**Subject:** Hornsea Project Three (UK) Ltd response to Deadline 4 (Part 2)  
**Date:** 15 January 2019 22:56:05  
**Attachments:** [image003.png](#)  
[D4\\_HOW03\\_BoR\\_Schedule\\_of\\_Changes.pdf](#)  
[D4\\_HOW03\\_CASchedule\\_Annex\\_A\\_rev2.pdf](#)  
[D4\\_HOW03\\_Hearing\\_Speaker\\_Biographies.pdf](#)  
[D4\\_HOW03\\_SoComm.pdf](#)  
[D4\\_HOW03\\_Statement\\_of\\_Reasons\\_Clean\\_Copy.pdf](#)  
[D4\\_HOW03\\_Statement\\_of\\_Reasons\\_Tracked\\_Changes.pdf](#)  
[HOW03\\_SoCG\\_BDC\\_January\\_2019.pdf](#)  
[HOW03\\_SoCG\\_Highways\\_England\\_15\\_January\\_2019.pdf](#)  
[HOW03\\_SoCG\\_MMO\\_January\\_2019.pdf](#)  
[HOW03\\_SoCG\\_NCC\\_January\\_2019.pdf](#)  
[HOW03\\_SoCG\\_SNC\\_January\\_2019\\_Final.pdf](#)  
[HOW03\\_SoCG\\_Vanguard\\_Boreas\\_D4\\_signed.pdf](#)

Statement of Common Ground between Hornsea Project Three  
(UK) Ltd. and South Norfolk Council

Date: January 2019

DRAWING TITLE  
Onshore HVDC Converter/HVAC Substation  
A47 Photomontage Viewpoint Location

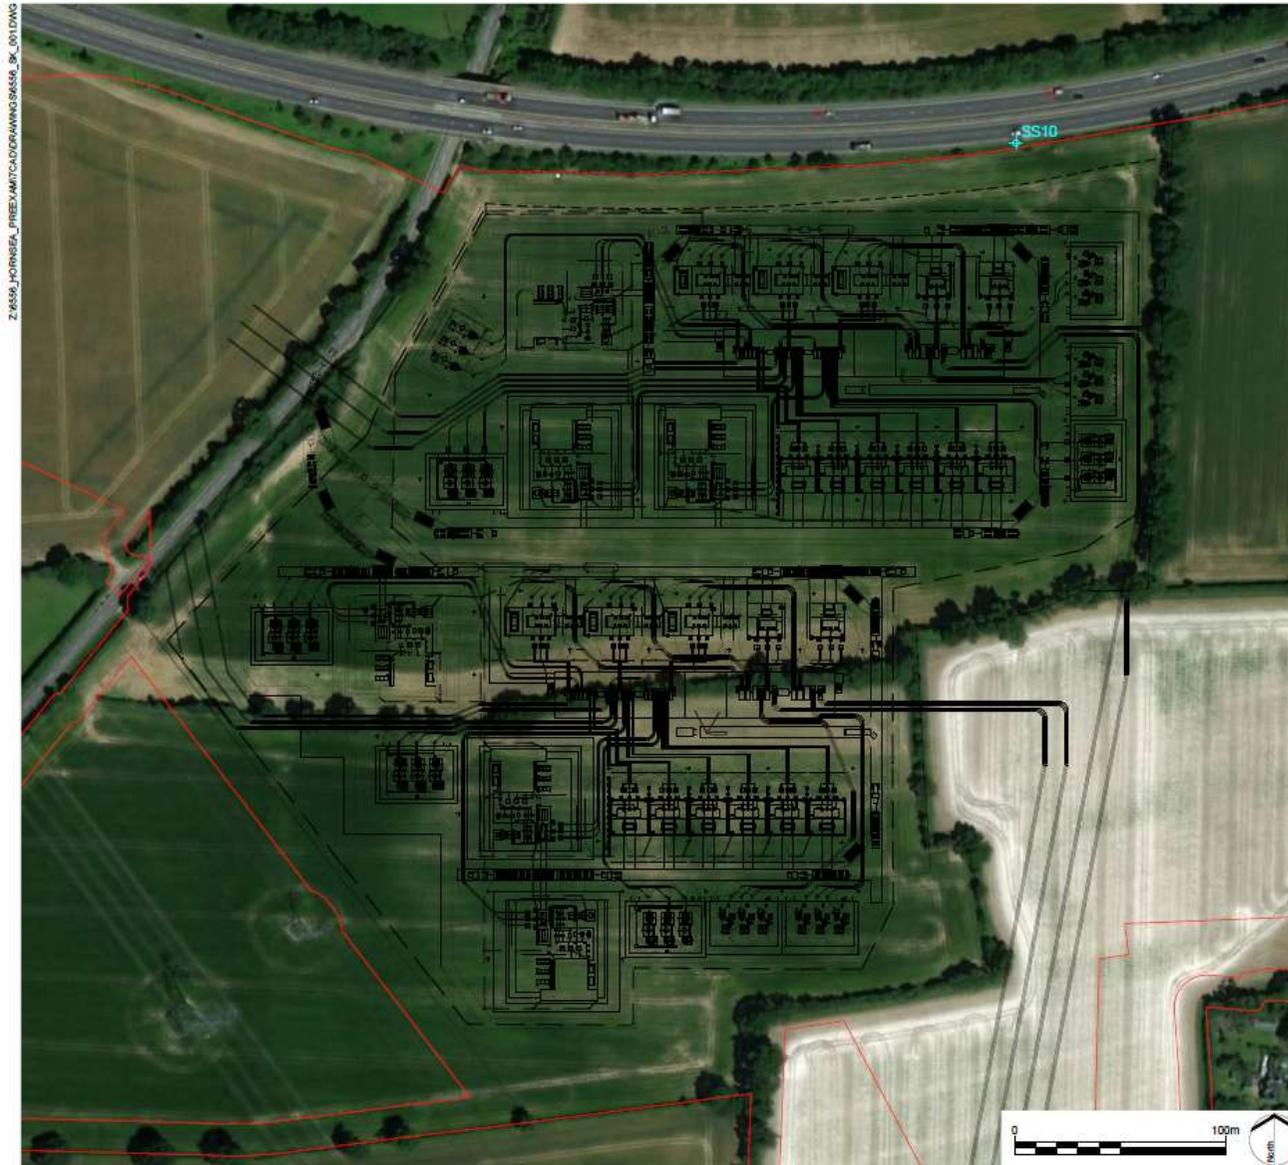
The location of the viewpoint is shown in Figure A.1, whilst a copy of the photomontage is shown in Figure A.2 (\*note this has been reduced in quality to allow submission within the file size required, but full resolution images were provided to SNC).

The photomontage shown overleaf shows an indicative HVDC converter station (which represents the maximum design scenario in respect to landscape and visual, as well as heritage impacts).

The landscape proposals are as illustrated on Drawing Number 6117\_510 of the Outline Landscape Management Plan (Rev 1) [REP1-145]. Woodland planting at year 15 is shown at approximately 4.9m height as stated in Table 3.2 of Volume 6, Annex 4.5 - Photograph Panels, Wirelines and Photomontages of the Environmental Statement [APP-146].

The photomontages do not alter the conclusions of Volume 3, Chapter 4 - Landscape and Visual Resources of the Environmental Statement [APP-076], including effects on users of the A47 set out in paragraphs 4.11.2.88 to 4.11.2.94.
